**Design Review Board  
Regular Meeting**

**Tuesday, November 8, 2022, 7:00 P.M.  
AGENDA**

**REPORT TO DESIGN REVIEW BOARD**

## REPORT TO DESIGN REVIEW BOARD

**Figure 2: Existing Lot Lines**

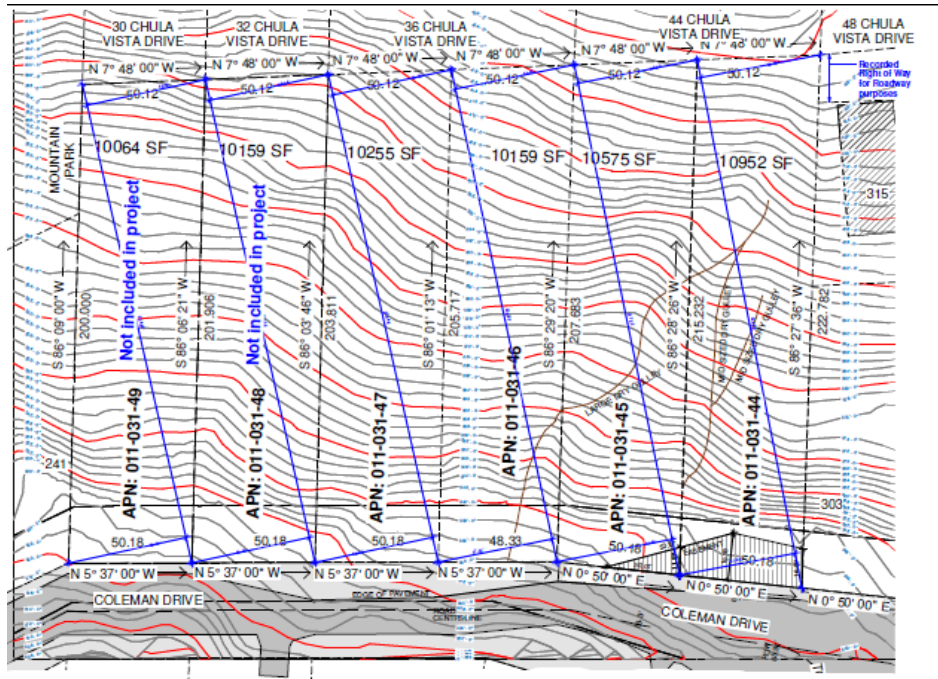
The applicant is proposing a lot line adjustment between four lots APNs 011-031-44 - 47 (Figure 2) to consolidate the lots, forming two lots: APNs 011-031-44 & 45; 011-031-46 & 47 (Figure 3). On each lot, the applicant proposes to construct the following:

**Figure 4: Site Plan for Lots 44 & 45**

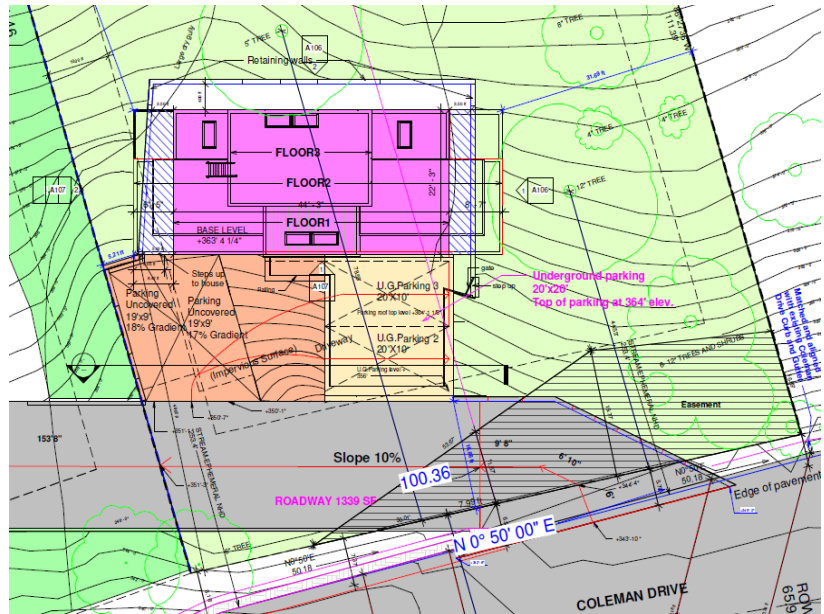
The retaining wall behind the building will be approximately 14'-8" in height. The retaining wall on the front elevation will be up to 14'-0" in height and will form the wall of the parking stalls. A trellis attached to the retaining walls will support creeping plants. As mentioned previously, because the height of the retaining wall exceeds 4'-0", they will require DRB recommendation. There will be a 2'-0" tall off-red color-treated pressure-treated pine fence located along the front and side property lines in the front yard.
